## TOWN OF HORIZON CITY Planning and Zoning Commission Staff Report

Case No.: SUC23-0002 Weaver & Kenazo

Application Type: Preliminary & Final Subdivision Plat Applications

**P&Z Hearing Date:** November 20, 2023 **Staff Contact:** Art Rubio, Planner

#### **Attachment 4: Preliminary Subdivision Plat**

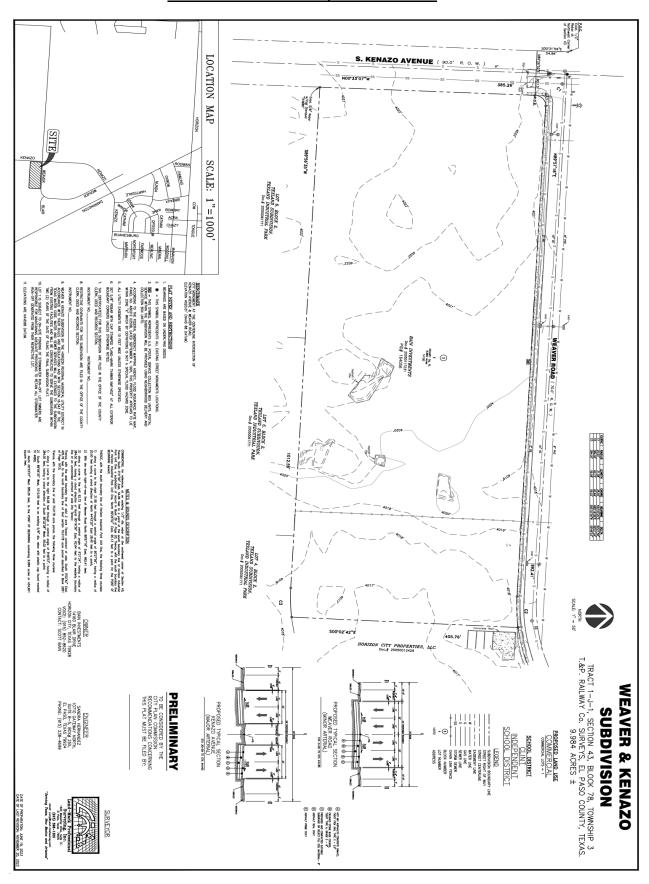
- 1. Verify legal description and spell out on heading on Preliminary and Final Plat.
- 2. Specify the R.O.W that is being dedicated?
- 3. Weaver cross section is called out as proposed ROW, is the owner proposing to improve Weaver or should it be existing R.O.W?

- 1. Show ponds. Improvement plans do not show on site ponding. Piping system is being proposed to drain into city pond.
- 2. Provide a note stating ''Grading plan/permit is required at the time of the Building permit.''
- 3. Provide Benchmark elevation.
- 4. Missing/Incorrect distance at west side of parcel as it does not match Metes & Bounds description. See redlines.
- 5. On the notes, add Half of S. Kenazo Ave. will be improved as part of this development.
- 6. Provide easements. All easements pertaining to this parcel must be shown.
- 7. Adress redline comments.

- 1. Address redlines, and comments provided on the plat.
- 2. Show size of existing utilities,
- 3. Provide the address of the lot.
- 4. Provide benchmark elevation using existing monument at the intersection S.

Kenazo Ave and Weaver Rd as datum.

- 5. Label point of commencing (POC) and point of beginning (POB) corresponding to the metes and bounds description.
- 6. Show existing monument at Weaver Rd and S. Kenazo Ave.
- 7. Make sure both M&Bs and table match (see plat for red lines).
- 8. Include fence line description in legend (see plat for red lines).

- 9. Verify that Metes and Bounds Description match plat boundaries (see plat for red lines).
- 10. Verify if other supplemental recorded pages to Horizon Industrial Park Unit One are shown on plat.
- 11. Rebar diameter size on southwest corner of said plat does not match plat description. VERIFY.
- 12. West boundary of plat metes and bounds description does not match plat. Verify.
- 13. Verify and show any utility easements and dimensions inside platted area.
- 14. Provide a closure report for the subdivision to ensure closure.

#### **Attachment 5: Final Subdivision Plat**

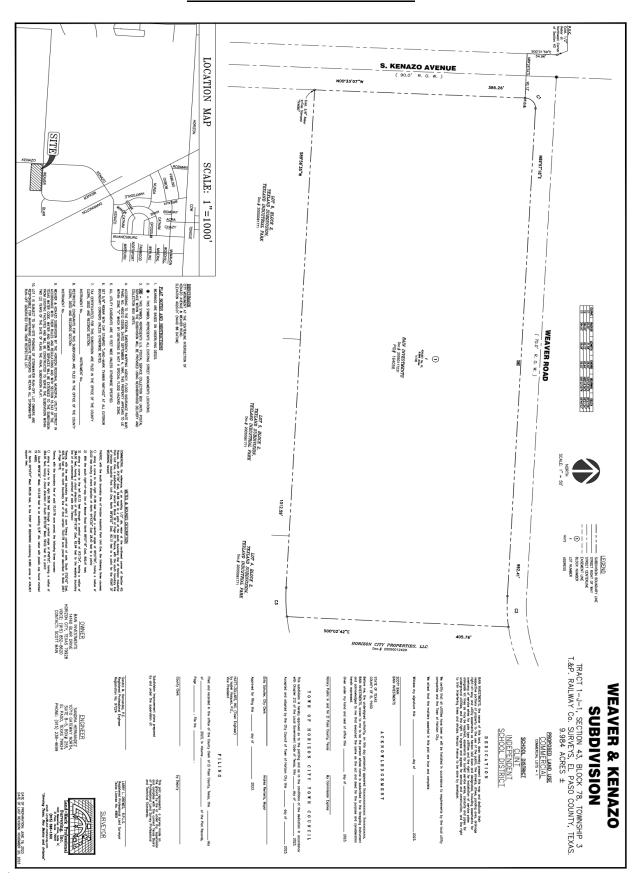
- 1. Provide Closure with metes and bounds description.
- 2. Provide a note stating ''Grading plan/permit is required at the time of the Building permit.''
- 3. Provide Benchmark elevation.
- 4. Missing/Incorrect distance at west side of parcel as it does not match Metes & Bounds description. See redlines.
- 5. On the notes, add Half of S. Kenazo Ave. will be improved as part of this development.
- 6. Provide easements. All easements pertaining to this parcel must be shown.
- 7. Adress redline comments.
- 8. Missing address.
- 9. El Paso County 9-1-1 District approval is required for the address
